MONTGOMERY COUNTY HISTORIC PRESERVATION COMMISSION
STAFF REPORT

Address:	507 New York Ave., Takoma Park	Meeting Date:	6/23/2021
Resource:	Non-Contributing Resource Takoma Park Historic District	Report Date:	6/16/2021
Applicant:	Jason Lange Nestor Gomez, Agent	Public Notice:	6/9/2021
Review:	HAWP	Tax Credit:	n/a
Permit No.:	954472	Staff:	Dan Bruechert
Proposal:	Porch Enclosure

STAFF RECOMMENDATION

Figure 1: 507 New York Ave.

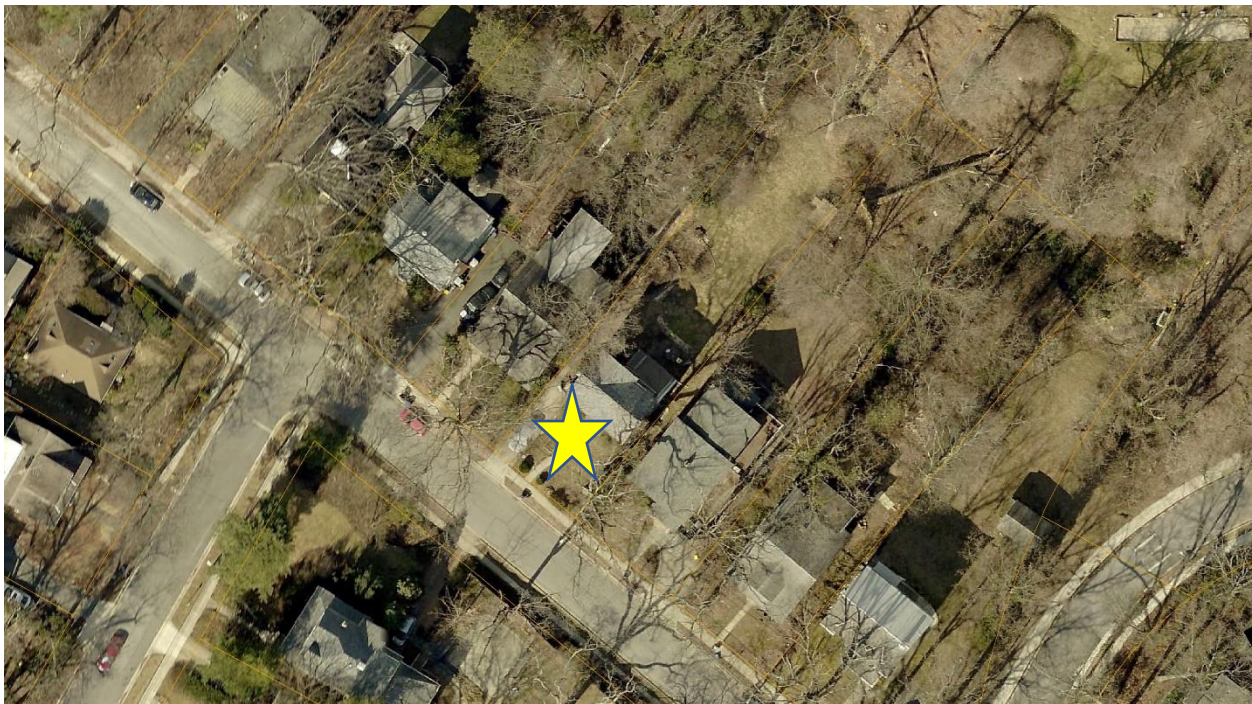
The existing sunroom is a partially enclosed rear porch with a shed roof on brick piers. The applicant proposes to renovate the sunroom with new siding, windows, and skylights. Staff finds the work is compatible in character with the existing house and will not be visible from the right-of-way and recommends the HPC approve the HAWP.

As constructed, the existing porch does not contribute to the historic character of the house or the surrounding district. Staff supports removing the exiting siding and windows. In place of the existing siding, the applicant proposes to install fiber cement clapboards. Staff finds this is an appropriate material for new construction at the rear. On the roof, the applicant proposes to install two skylights. Staff finds these will not change the character of the roof and, were it not for the other work proposed in this HAWP, would have approved these at the Staff Level. The final change proposed is the new windows. The applicant proposes to install two pairs of six-over-one sash windows and a single lite, fixed window with frosted glass (this window is proposed for the new interior bathroom). No window specification was included with the HAWP application. Because this is a Non-Contributing Resource in a location that is not at all visible from the right-of-way, Staff finds virtually any window would be appropriate. Staff recommends the HPC include a condition for approval that permit drawings may not be stamped until a window specification is provided and final approval authority is delegated to Staff.

Staff recommends the HPC **approve** the HAWP with one condition:

1. Window specifications are required before Staff can stamp the permit drawings. Final review and approval authority for the proposed windows is delegated to Staff.
